Village of Arlington Heights
Plan Commission
Board Room
Arlington Heights Village Hall
33 S. Arlington Heights Road
Arlington Heights, IL 60005
September 9, 2015
7:30 PM

- A. Xilin Adult Day Care - 145 E. Algonquin Rd. - PC#15-011
Land Use Variation
- B. Olive-Mary Stitt School - 303 E. Olive St. - PC#15-015
Special Use for a School
- C. Ivy Hill School - 2211 N. Burke Dr. - PC#15-016
Special Use for a School

OLIVE-MARY STITT SCHOOL

Sheet No:
C-3.1

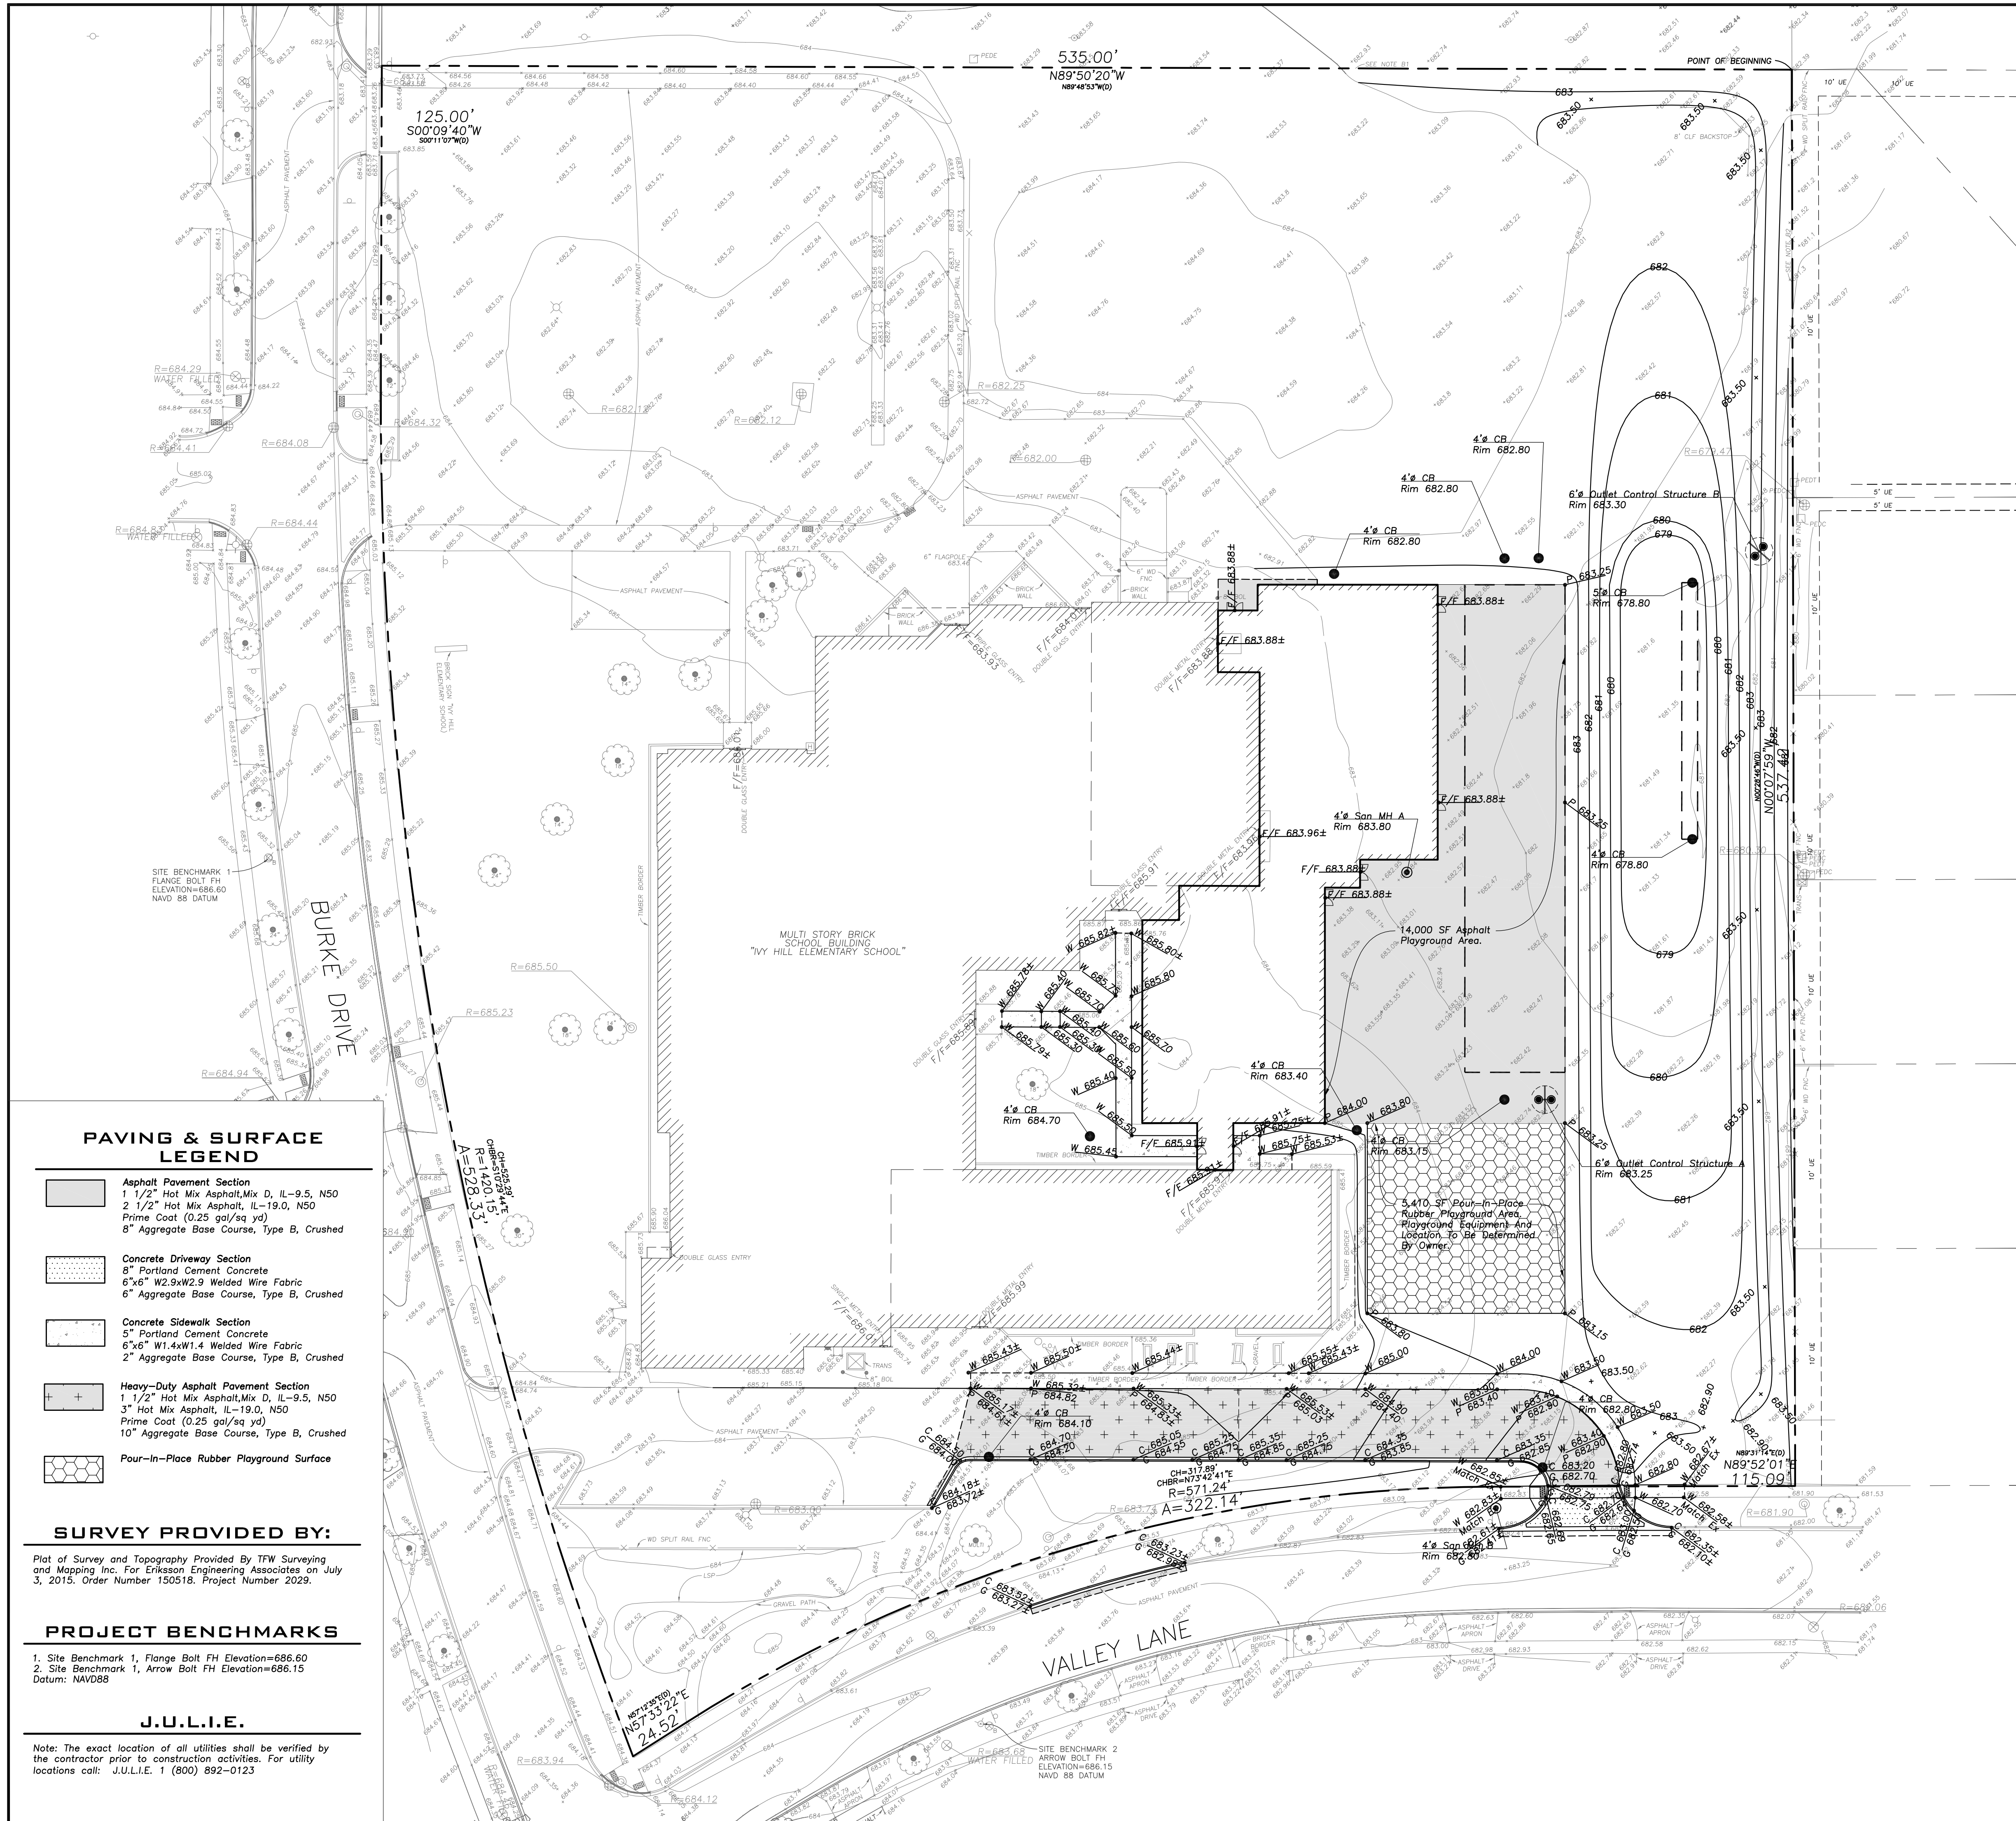
18. Sheet C-3.1: The new sanitary service line shall be blind connected to the public sewer main. No need to replace the existing public manhole.

C-5.1

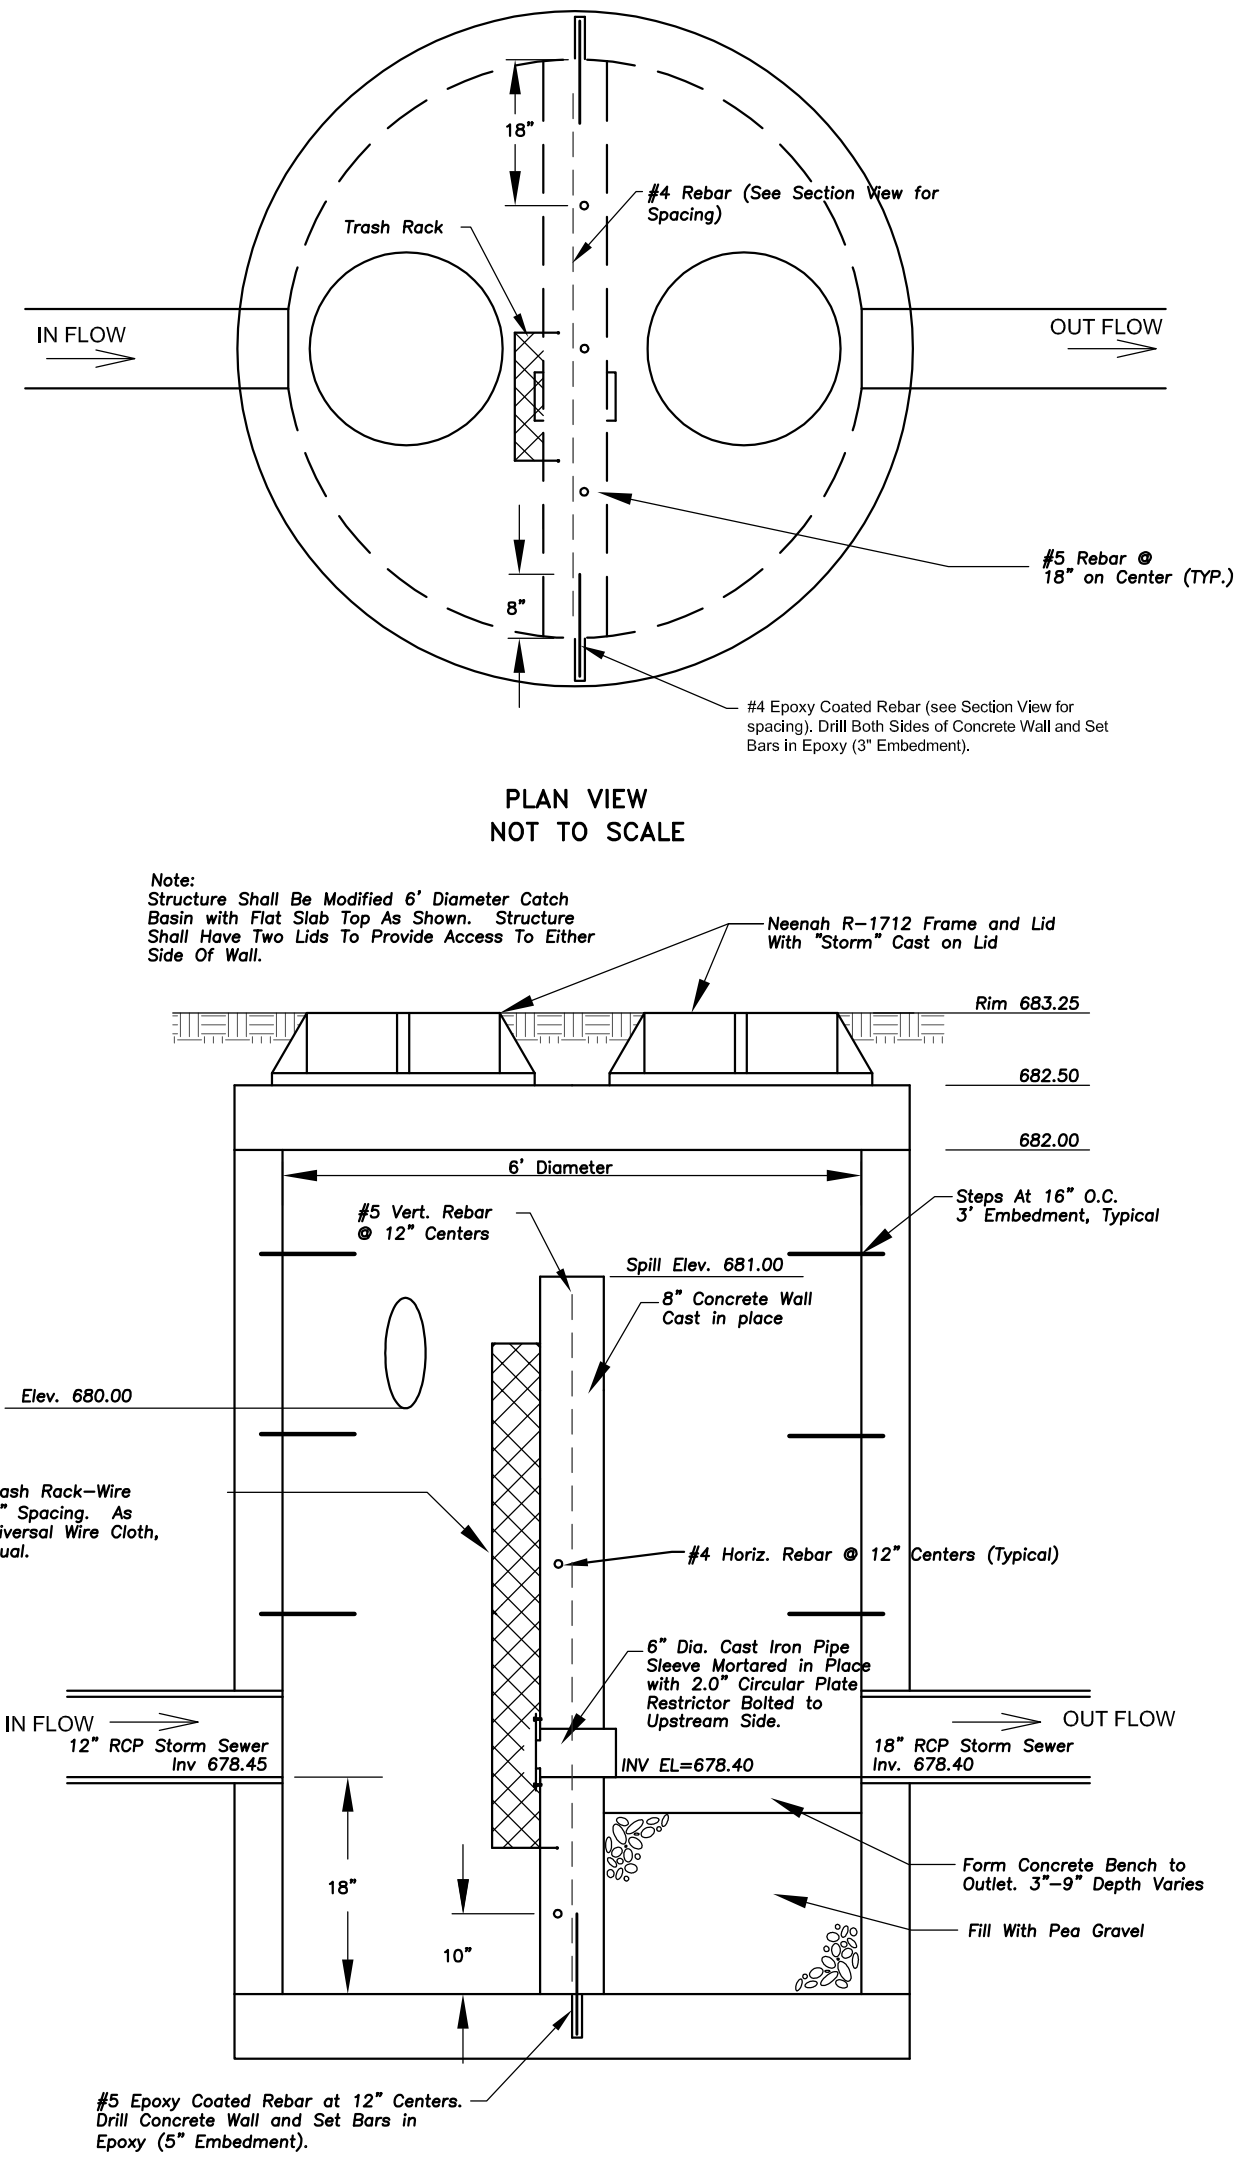
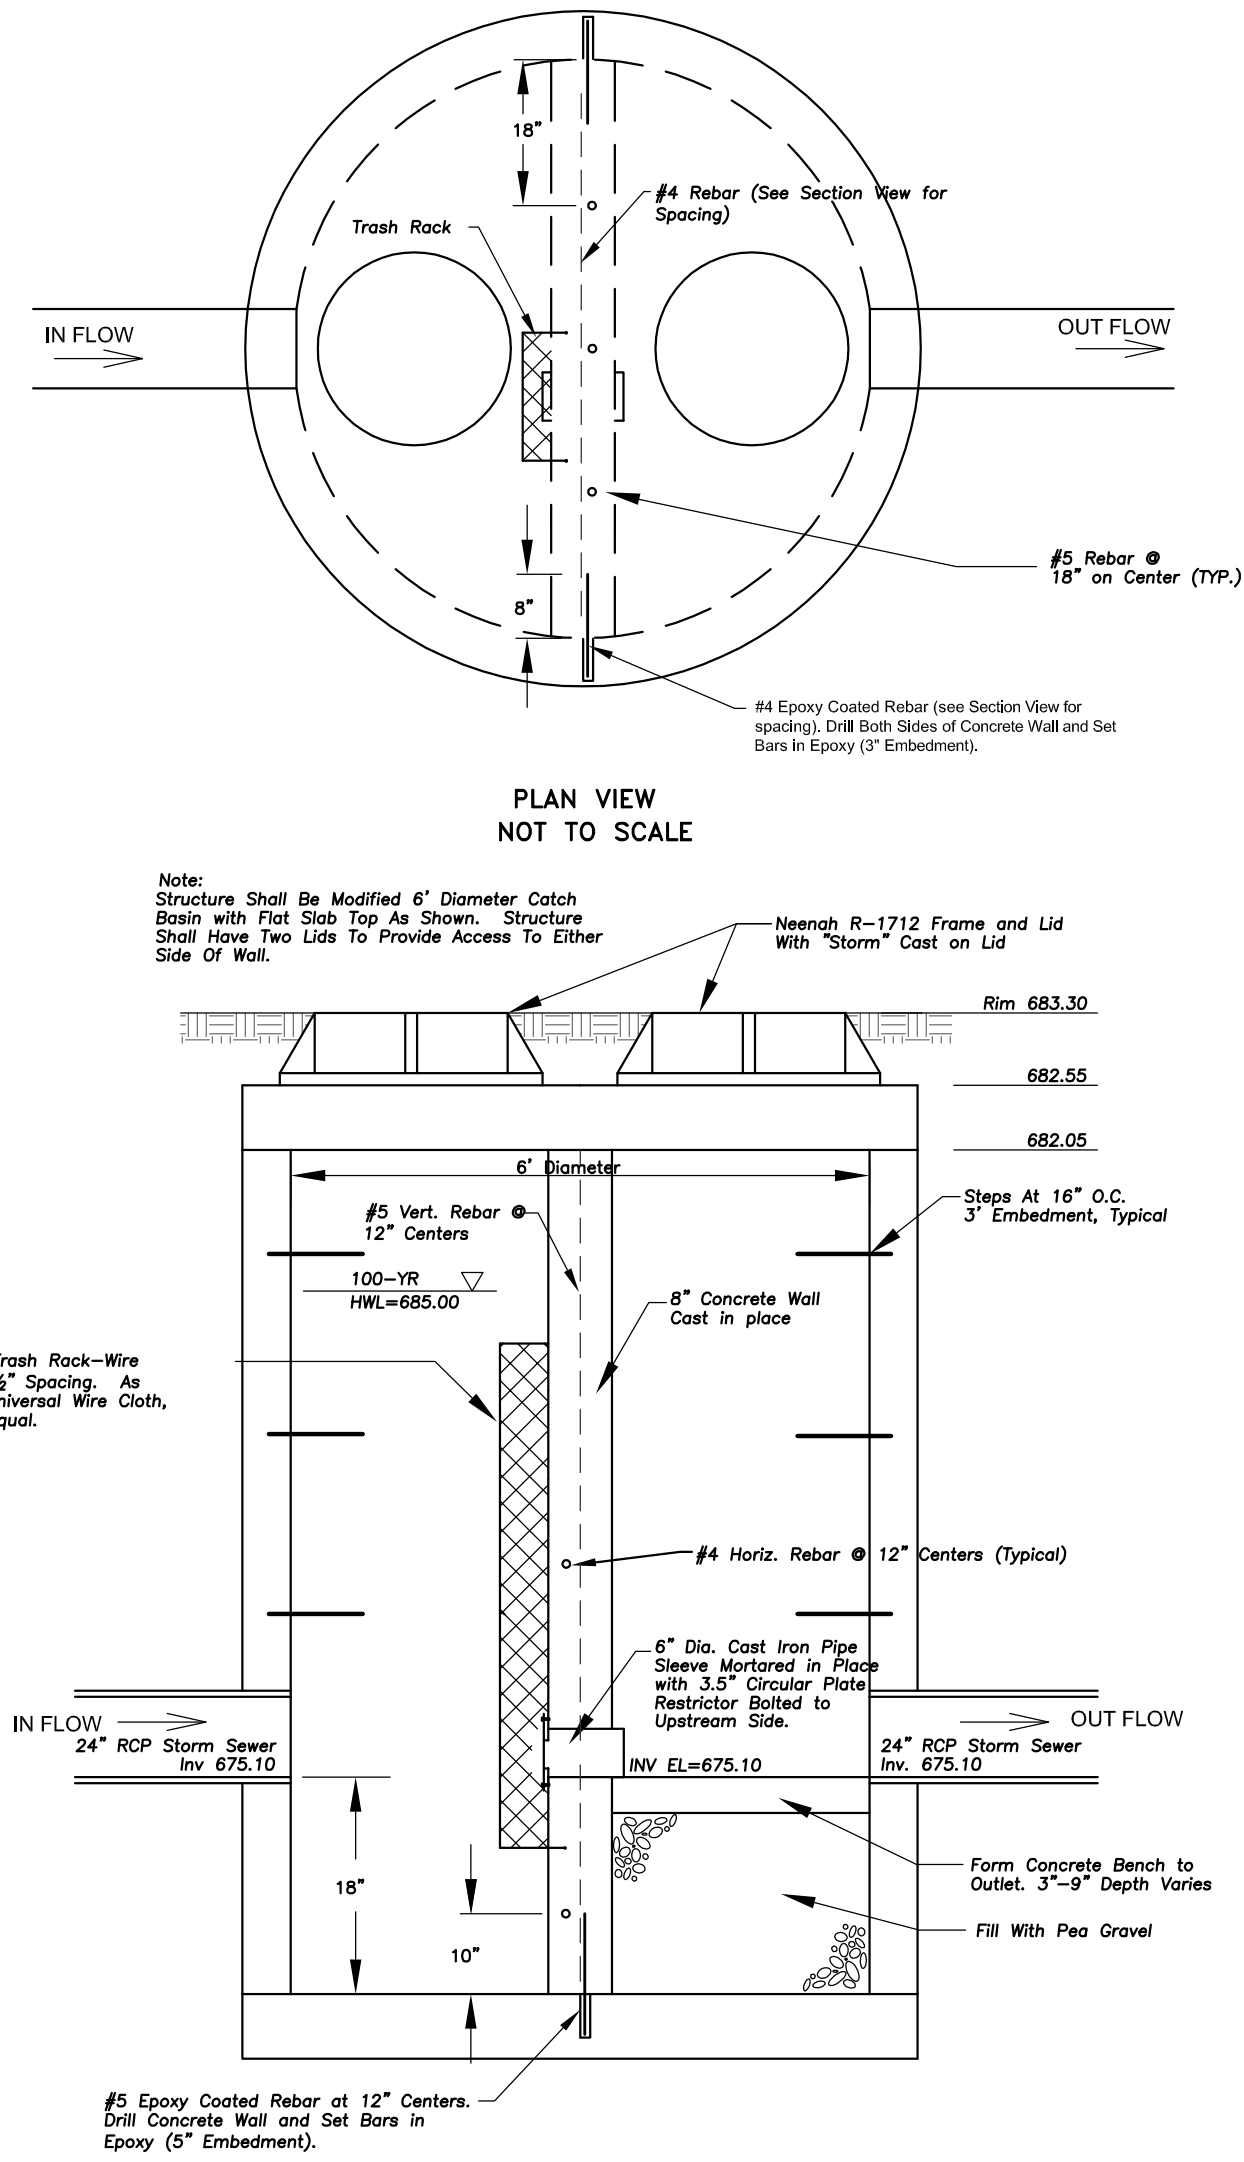
19. Sheet C-6.1: Verify the elevations shown on the details for the outlet control structures.
